Development Application No: DA2025/0581 for Construction of a swimming pool at 316 Hudson Parade CLAREVILLE.

An assessment has been undertaken of your application. The assessment has found that it is unsatisfactory in its current form for the reasons identified below:

Foreshore Building Line (FBL), faint red line in the aerial image as extracted from Council's data base (SEA programme) compared with the FBL as annotated on the location plan

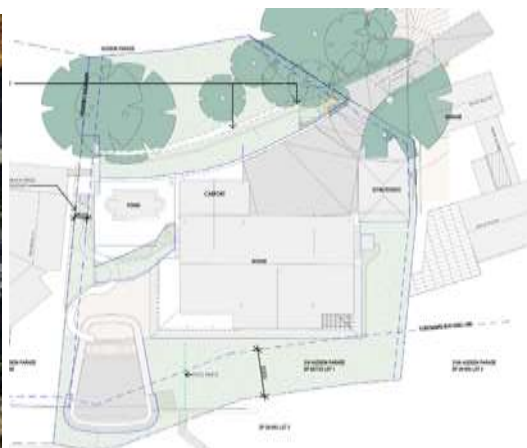
1. The PAN form includes lot 2 DP827733 as being part of the subject site. Lot 2 is owned by Council and owner's consent has not been submitted from Council. Two separate emails from Baxter and Jacobson architects, dated 14 May and 18 June 2025 have confirmed that all work is within lot 1 and no work is proposed in lot 2. To address this inconsistency please submit a letter to clarify the correct address of the site as lot 1 DP827733.
2. The foreshore building line appears to be incorrectly annotated on the architectural drawings. Council records suggest that the line is set back 6.2m to the north and 6.5m to the south, see screen shot below.
